Work Order ID 79839

### D3303-041 HEAD REST

DRAWING NO. D3303	TITLE HEAD REST	REV. B	<b>DART AEROSPACE LTD ENGINEERING ORDER</b>		D.E.O. NO. D3303-B-1	SHEET NO. SHEET 1 OF 1	SCALE NTS
DRAWN AJS	CHECKED b	MFG. APPR. M	APPROVED MAD		DE APPR. H		
DATE 08.10.15	DATE 08.10.15	DATE 08/10/16	DATE 08/10/16		DATE 08/10/16

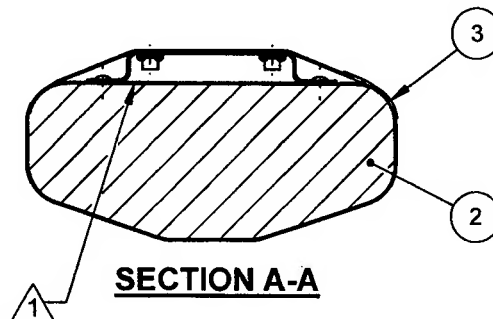
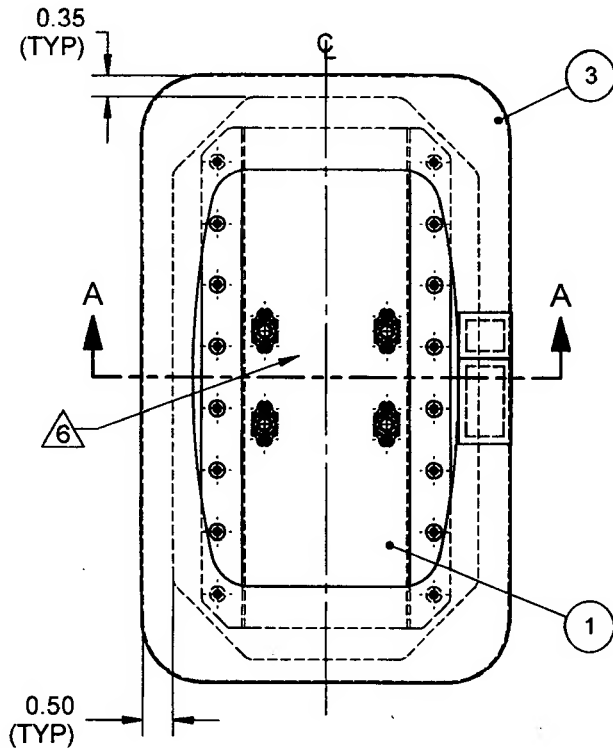
SHEET 1 ADD 1300L ADHESIVE BY 3M TO NOTE 1 AS FOLLOWS:

- 1) BOND D3305-1 FOAM TO D3303-043 BRACKET ASSEMBLY USING 3M 1300 ADHESIVE (0.002" TO 0.010" THICK) IN ACCORDANCE WITH MANUFACTURER'S INSTRUCTIONS

- 1) BOND D3305-1 FOAM TO D3303-043 BRACKET ASSEMBLY USING 3M 1300 OR 1300L ADHESIVE (0.002" TO 0.010" THICK) IN ACCORDANCE WITH MANUFACTURER'S INSTRUCTIONS
